Service Manual

36910A

Correction to Service Manual/Information

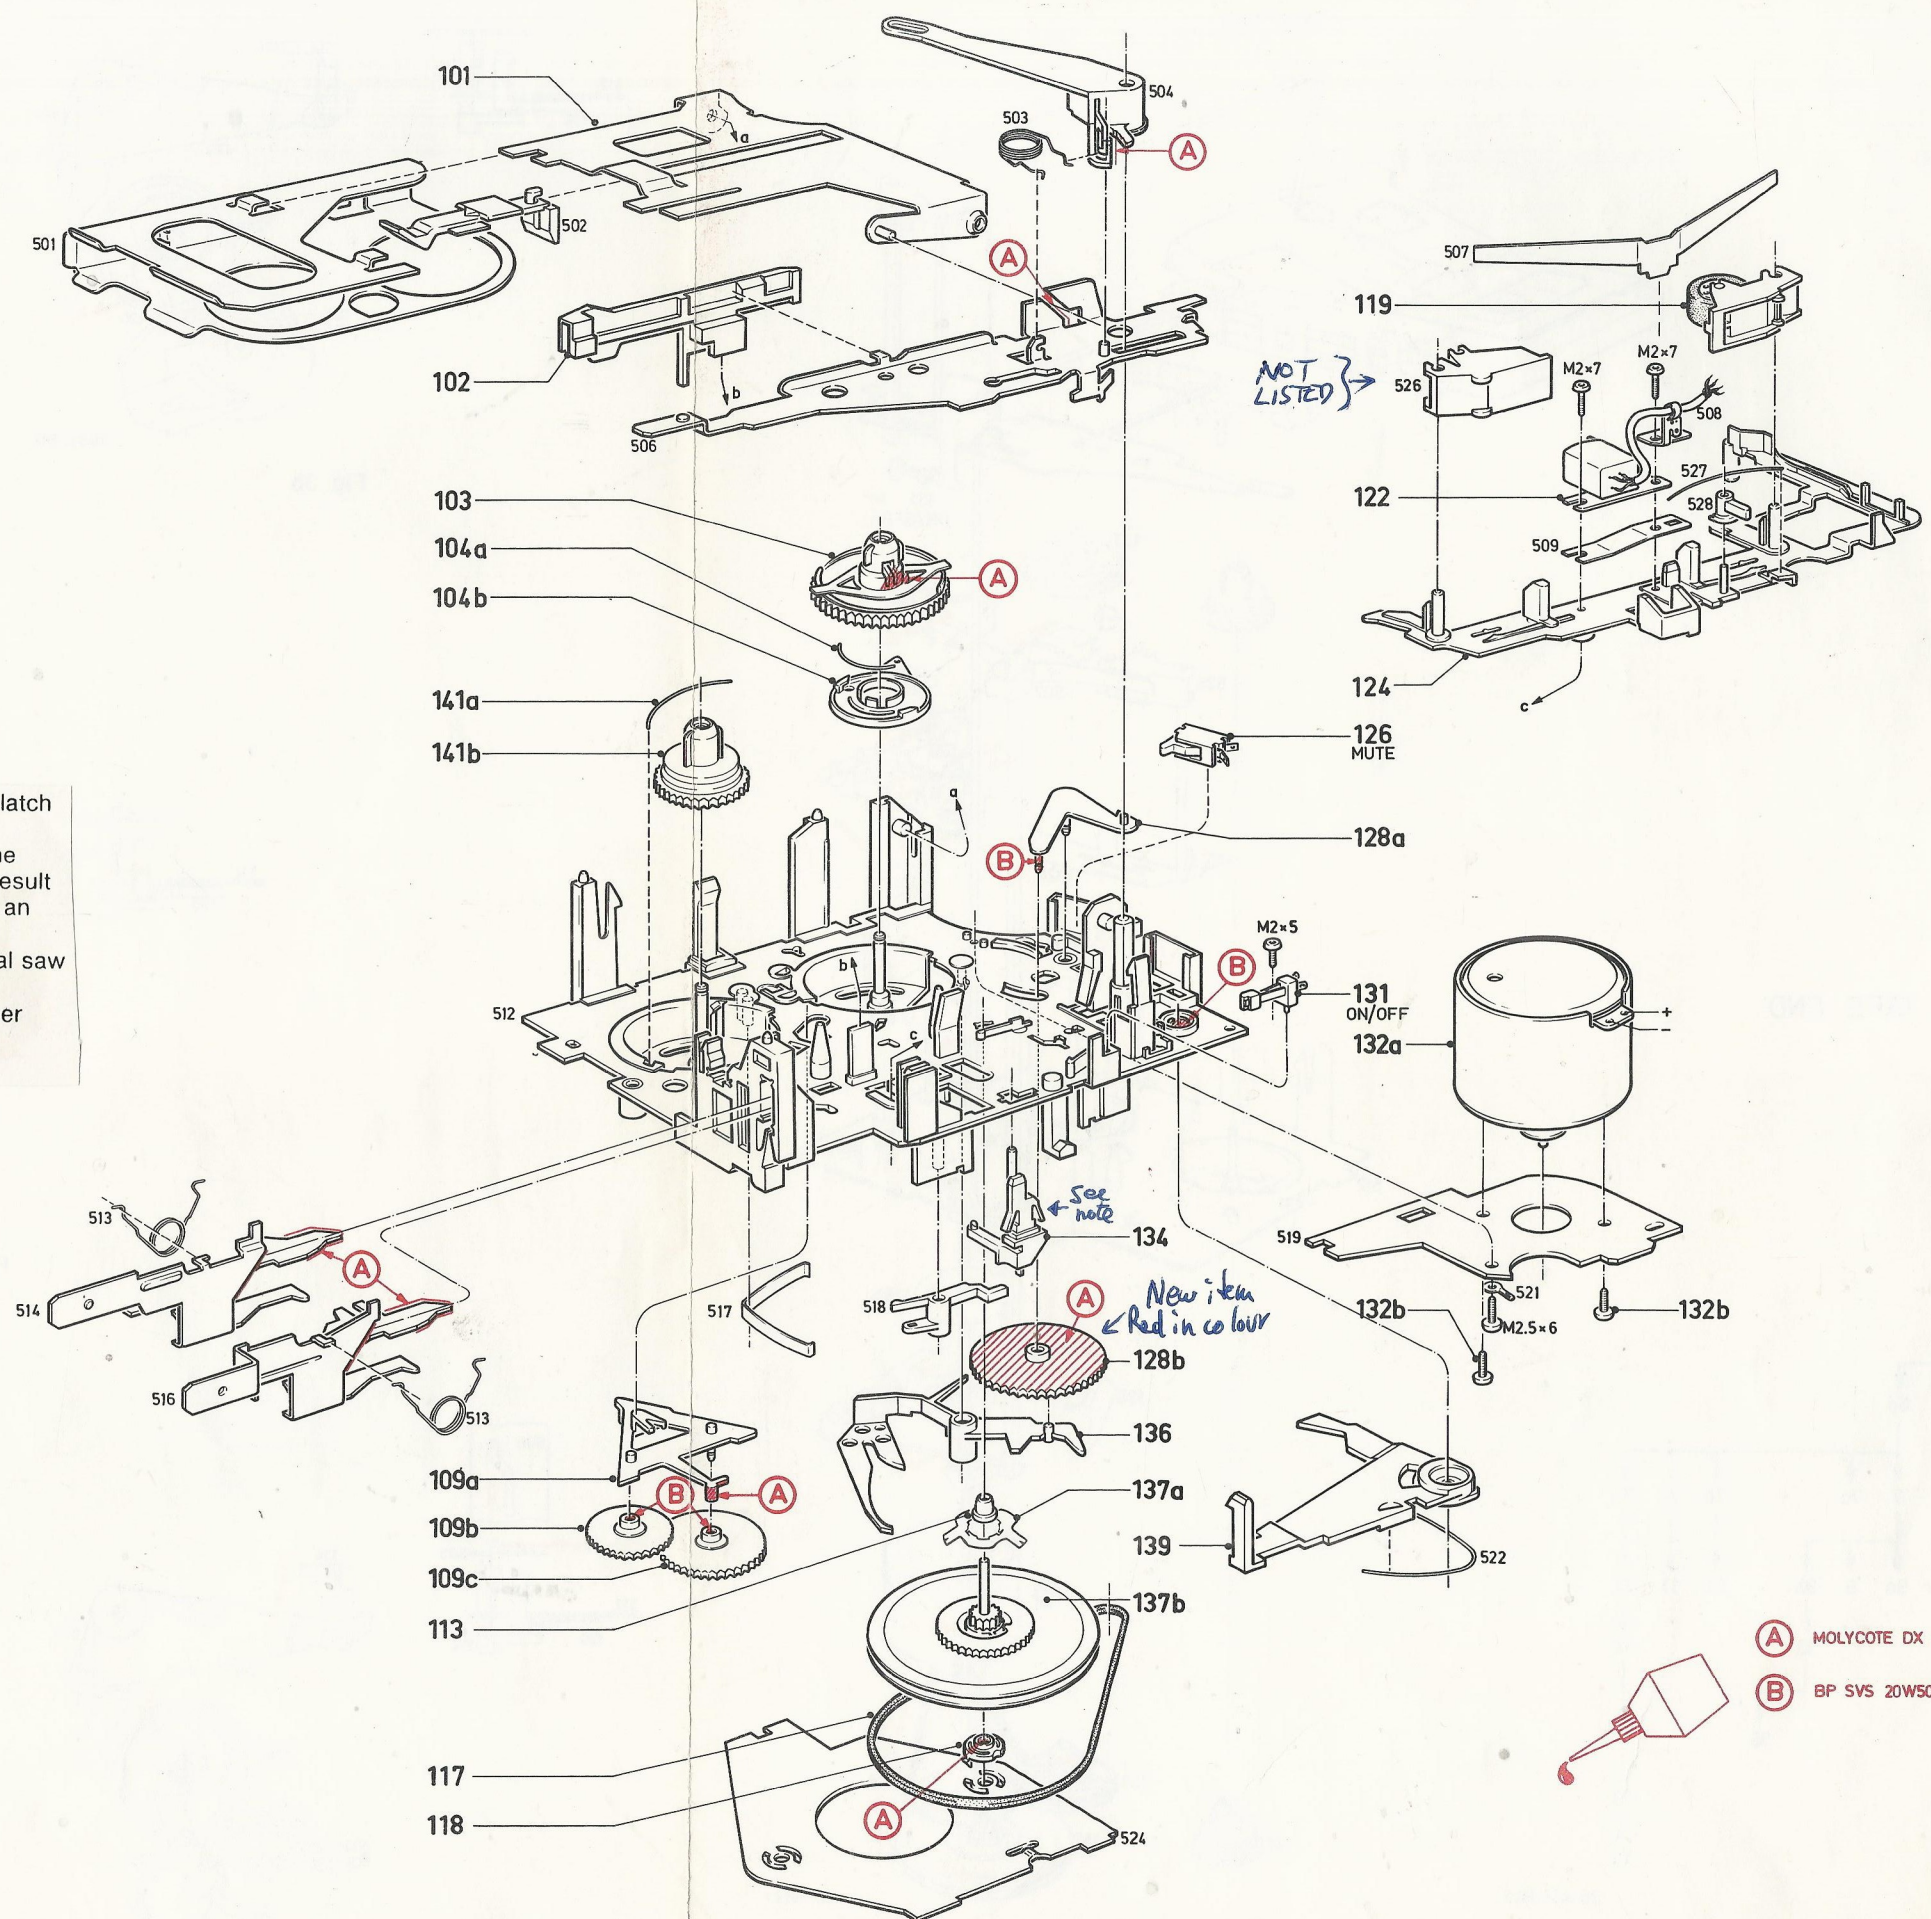
the production method of latch lever 134 has been changed. At the same time, however, an additional rib has been added and the clearance in chassis 512 locally increased. As a result it is impossible to mount a changed latch lever in an unchanged mechanism. There are two solutions:

- Enlarge clearance in chassis by means of metal saw and a smooth file. See Fig. 1.
- Replace the complete mechanism (order number 4822 701 10123).

Fig. 1

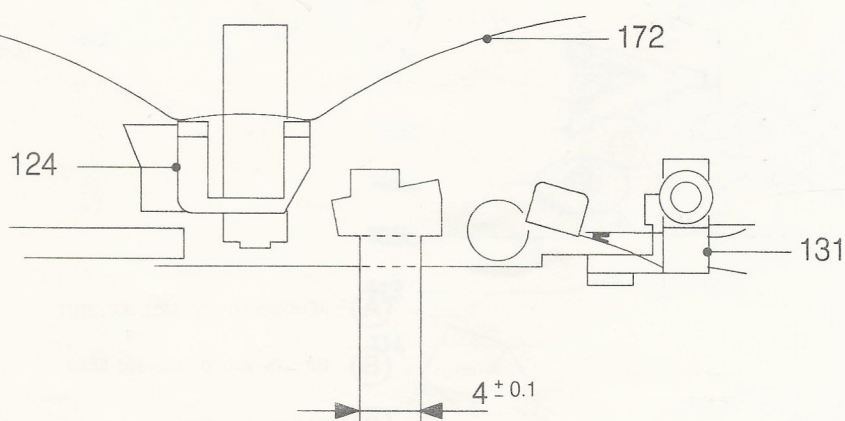
- A85-317 mentions that the production method of latch lever 134 has been changed. At the same time, however, an additional rib has been added and the clearance in chassis 512 locally increased. As a result it is impossible to mount a changed latch lever in an unchanged mechanism. There are two solutions:
 - a. Enlarge clearance in chassis by means of metal saw and a smooth file. See Fig. 1.
 - b. Replace the complete mechanism (order number 4822 701 10123).
